**REQUEST FOR COMMENT ON THE MODIFICATION APPLICATION AND REPORT FOR THE
MODIFICATION 9 LONGWALL REORIENTATION (SSD-5144)**

Thank you for the opportunity to provide comment on the proposed modification to the Mandalong Southern Extension Project involving the reorientation of the longwall mining panels to account for recently discovered geological conditions and the reduction in the number of planned longwall panels from eight to five.

Figure 1: Extract from Modification Report showing approved location of longwall 54

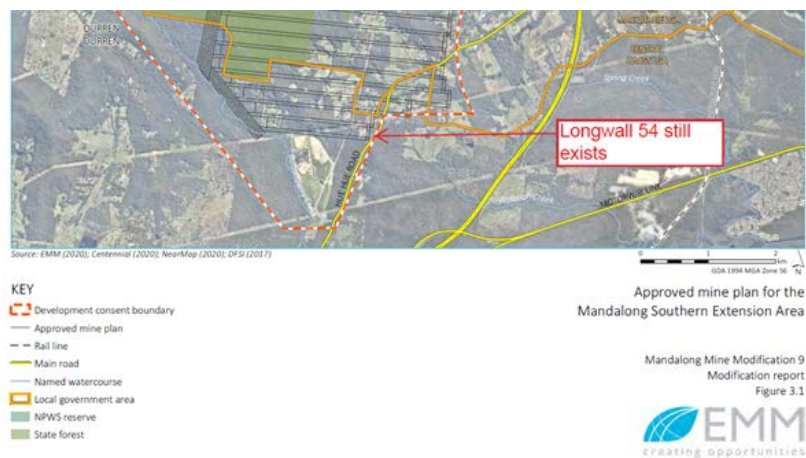
Additionally, concern is still raised for longwall 54 and the “main heading” which is shown to be extending inside the Buttonderry Waste Management Facility boundary as part of the

approved mine plan (refer page 15 of EMM document and figure 1 below). Concern was raised by council in 2014 regarding the likely impacts that longwall 54 would have upon the Buttonderry Waste Management Facility and the impacts that Buttonderry Waste Management Facility may have upon longwall 54. It was council's understanding that Centennial reviewed council's comments at the time and agreed that longwall 54 would not proceed and would be removed from the plans. It is acknowledged this longwall is not the subject of the proposed modification, however, consideration should be given by Centennial for the relocation or removal of longwall 54 from within the Buttonderry Waste Management Facility boundary.
